Title of Change:	Update to FPCN22643X - Update on the dimension comparison of DPAK & IPAK case outline.
Proposed First Ship date:	20 Dec 2019 or earlier if approved by customer
Contact Information:	Contact your local ON Semiconductor Sales Office or Daisy.Zhi@onsemi.com
PCN Samples Contact:	Contact your local ON Semiconductor Sales Office or <PCN.samples@onsemi.com>. Sample requests are to be submitted no later than 30 days from the date of first notification, Initial PCN or Final PCN, for this change. Samples delivery timing will be subject to request date, sample quantity and special customer packing/label requirements.
Additional Reliability Data:	Contact your local ON Semiconductor Sales Office or Lake.Wang@onsemi.com
Type of Notification:	This is a Final Product/Process Change Notification (FPCN) sent to customers. FPCNs are issued 90 days prior to implementation of the change. ON Semiconductor will consider this change accepted, unless an inquiry is made in writing within 30 days of delivery of this notice. To do so, contact PCN.Support@onsemi.com

Final Product/Process Change Notification

Document #:FPCN22643X1

Issue Date:20 Dec 2019

• **Table 1 : Old vs New Comparison for DPAK dimension**

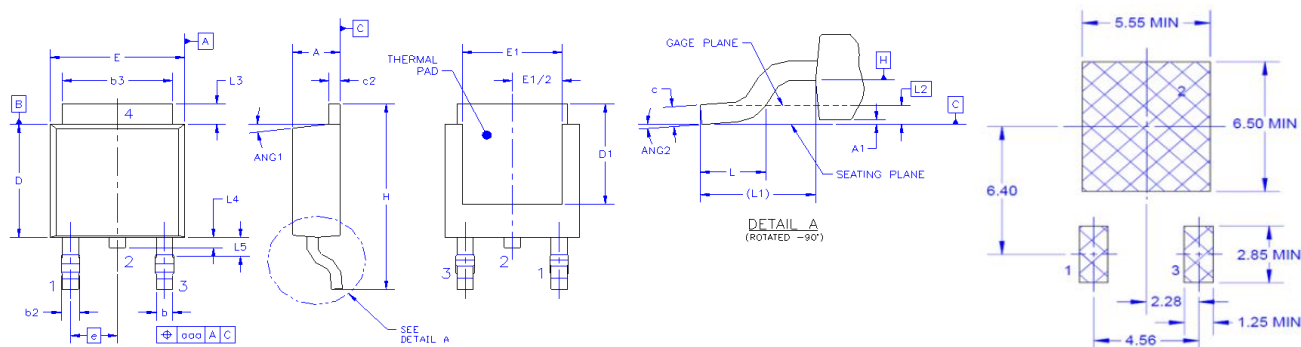
Update some dimensions for DPAK Non-JEDEC(369AK) and DPAK JEDEC(369AS)

- 1) Delete "NOM" item in the comparison table
- 2) Some dimension changes on below item:

Dimension in previous PCN FPCN22643X

REF	DESCRIPTION	Old Dimension (DPAK NON-JEDEC)			New Dimension (DPAK JEDEC)		
		MIN	NOM	MAX	MIN	NOM	MAX
A1	Profile height	-0.05		0.2	---		0.127
e	Lead pitch	2.08	2.28	2.48	---	2.29	BSC
L	Foot length	1.4	----	1.7	1.4	1.59	1.78
L2	Gage plane	0.49	0.5	0.51	---	0.51	BSE
L4	Center lead cut length	----	----	----	0.64	0.83	1.02
ANG2	foot landing angle	----	----	----	0	---	10
aaa	Lead position tolerances	---	---	----	---	---	0.25

Dimension in new PCN FPCN22643X1

Old Dimension (DPAK NON-JEDEC, 369AK)		New Dimension (DPAK JEDEC, 369AS)	
MIN	MAX	MIN	MAX
---	0.127	---	0.127
2.08	2.48	---	2.29
0.55	----	1.4	1.78
1.02		0.51	
----	----	----	1.02
0	8	0	10
---	0.25	---	0.25

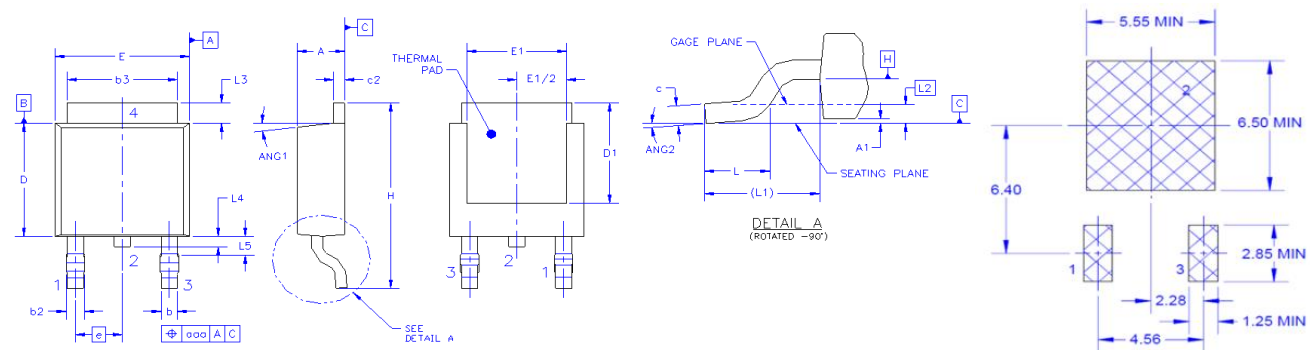
この更新通知は、表 1 と表 2 の寸法比較に関するいくつかの更新を通知します。							
表 1: DPAK 寸法の新旧比較							
DPAK Non-JEDEC (369AK) および DPAK JEDEC (369AS) の一部の寸法を更新							
1) 比較表の「NOM」項目を削除 2) 以下の項目の寸法変更:							
以前の PCN FPCN22643X の寸法							
REF	説明	古い寸法 (DPAK NON-JEDEC)			新しい寸法 (DPAK JEDEC)		
		MIN	NOM	MAX	MIN	NOM	MAX
A1	Profile height	-0.05		0.2	---		0.127
e	Lead pitch	2.08	2.28	2.48	---	2.29	BSC
L	Foot length	1.4	---	1.7	1.4	1.59	1.78
L2	Gage plane	0.49	0.5	0.51	---	0.51	BSE
L4	Center lead cut length	---	---	---	0.64	0.83	1.02
ANG2	foot landing angle	---	---	---	0	---	10
aaa	Lead position tolerances	---	---	---	---	---	0.25
新しい PCN FPCN22643X1 の寸法							
古い寸法 (DPAK NON-JEDEC, 369AK)		新しい寸法 (DPAK JEDEC, 369AS)					
MIN	MAX	MIN	MAX				
---	0.127	---	0.127

2.08	2.48	2.29					
0.55	---	1.4	1.78				
1.02		0.51					
---	---	---	1.02				
0	8	0	10				
---	0.25	---	0.25
